From: Noeleen Keavey
Sent: 09 August 2006 14:48
To: Ann Bosley
Subject: FW: RK1721 FW: Youghal - Review of AVR report

From: Sinead Hickey [mailto:sinead.hickey@sws.ie]
Sent: 11 July 2006 15:42
To: 'Valerie Hannon'
Subject: RE: RK1721 FW: Youghal - Review of AVR report

From: Cieciora, Paul A
Sent: Monday, July 10, 2006 1:06 PM
To: Murray, Kevin J
Subject: Youghal - review of AVR report

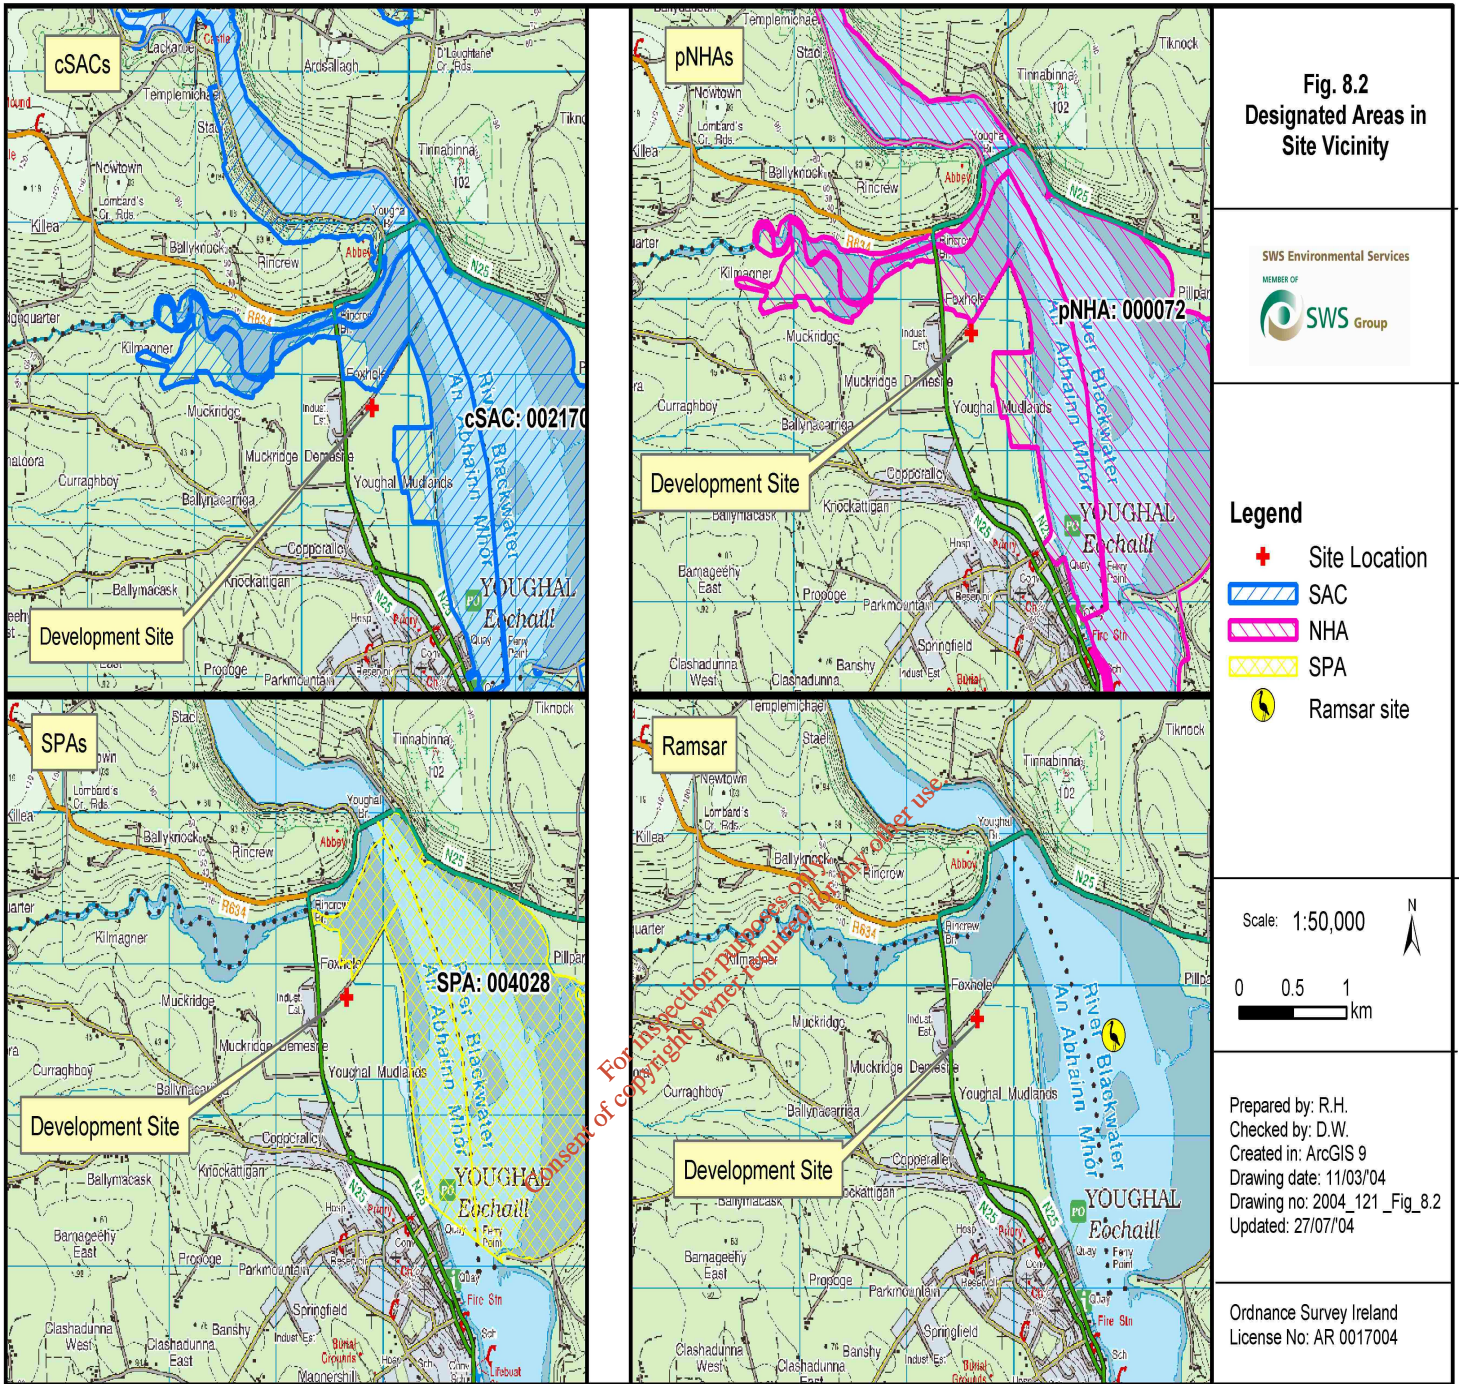
Also attached is a map showing the site relative to designated areas and a summary of the designations. I also got in touch at the time with Shane O' Boyle from EPA and also Liz Slides of NPWS and Chris Embro who were both involved with the Biomar study who confirmed that at the nearest monitoring site that no species of interest were recorded. Chris Embro was also involved in the survey undertaken at the

Fig. 8.X
Youghal Bay Monitoring
EPA Water Quality

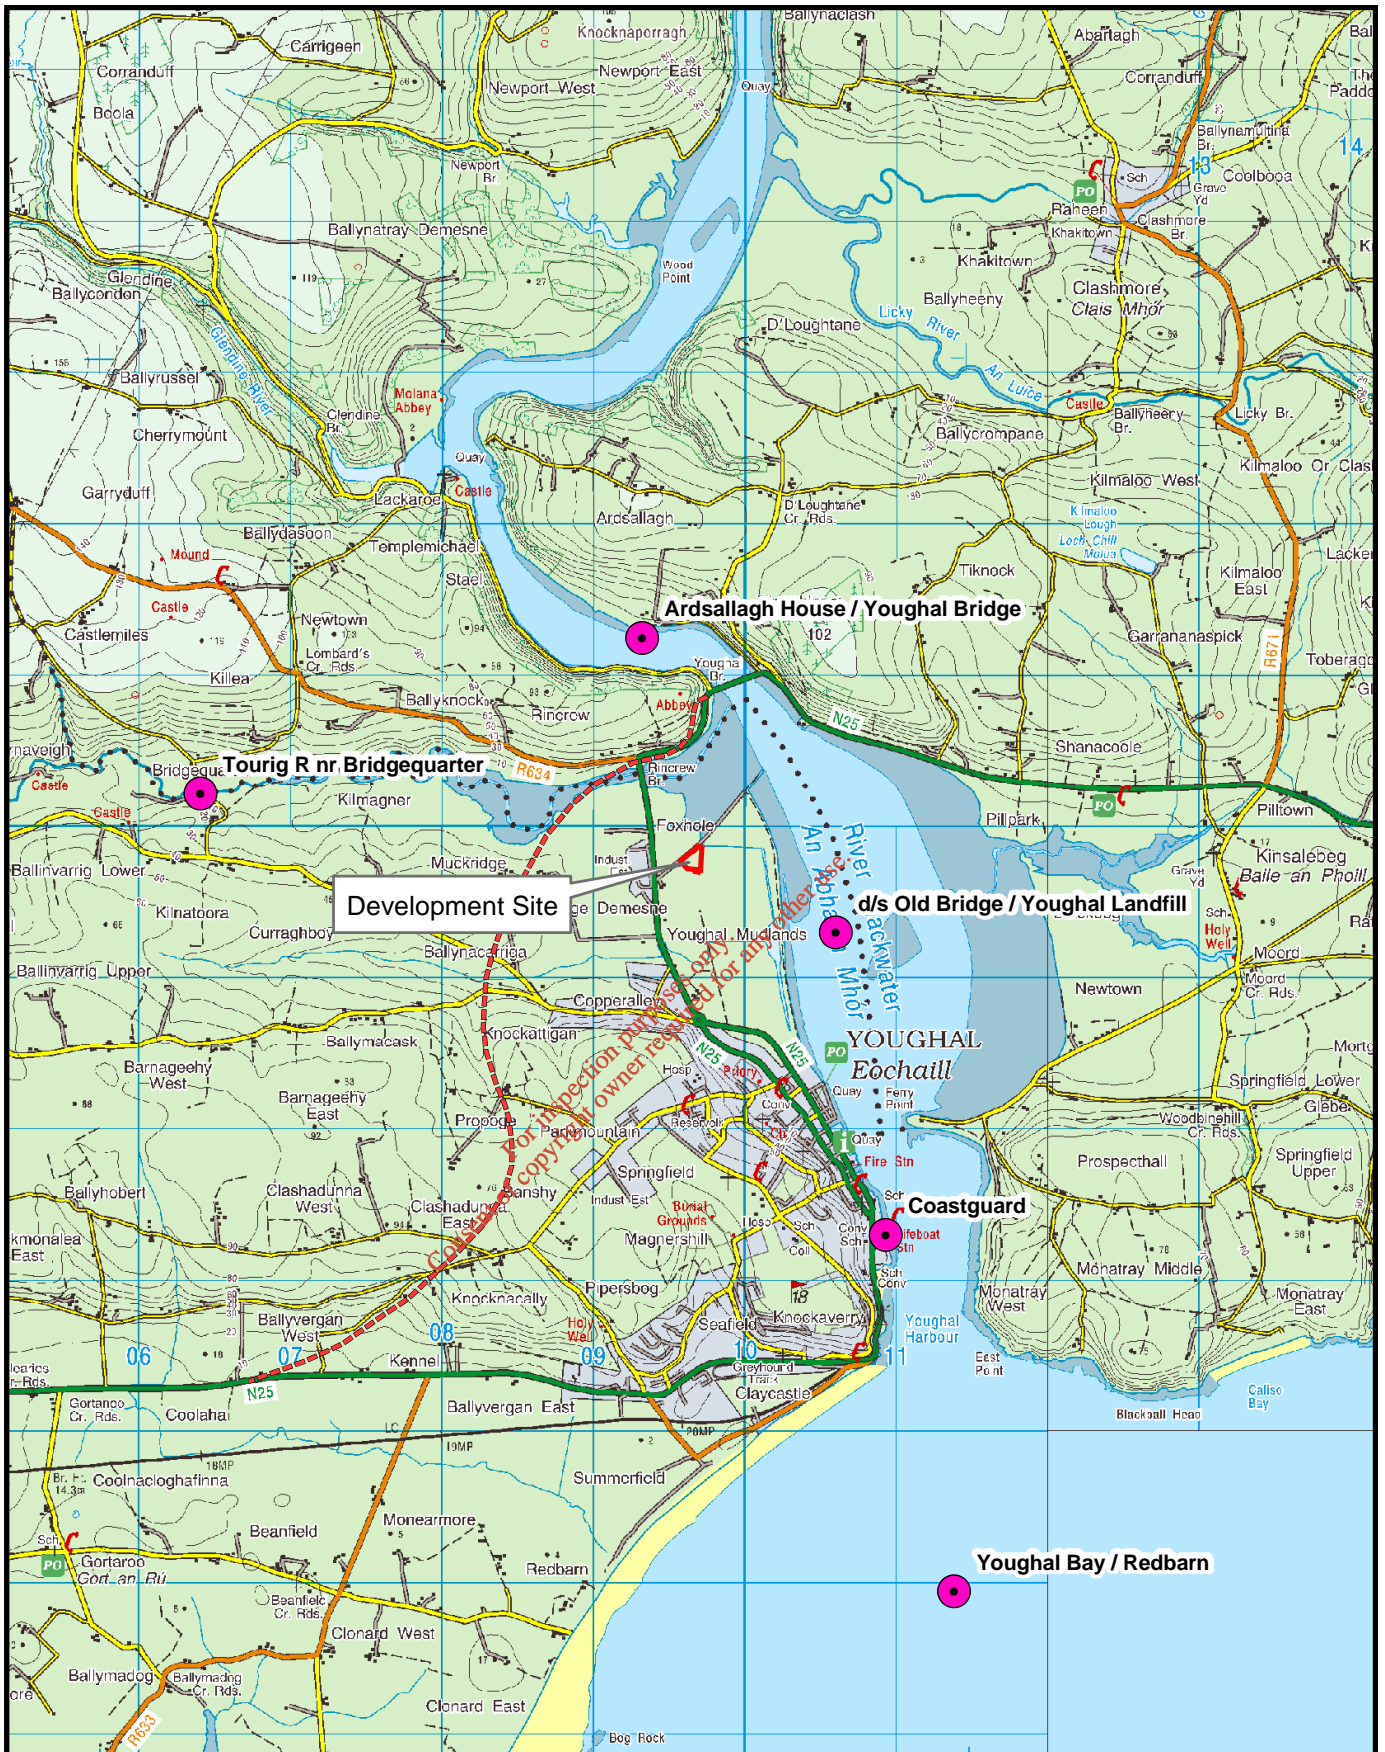
2. Attached is a map which shows the site discharge point to the outfall pipe at Foxhole, Youhal relative to the AVR plant. The discharge point is into the estuary and is out at the end of what remains of the old bridge. You can see the EPA monitoring points U/S and D/S of the discharge point. Youghal Town Council have no objection in principle to allowing the discharge to the outfall pipe at Youghal subject to meeting discharge requirements set by CCC and the EPA (letter attached). Therefore the modeling was undertaken with respect to the chemical and biological parameters to ensure that the discharge and extent of mixing zone is compatible with the receiving water. Because this outfall will be discontinued in the medium term when the Yougal Waste Water Treatment System comes into operation (in about 5 years time from speaking with the Sanitary Division of CCC) the discharge had to meet, at a minimum the requirements of the Urban Water Water Directive and also meet other relevant discharge parameters as outlined in the additional information submitted to the EPA based on discussion with the licencing officer. The condensate has therefore to be treated on site and then in c 5 years the treated discharge will be sent to Yougal Waste Water Treatment System when constructed as the EPA do not really want a number of discharge points into the bay.
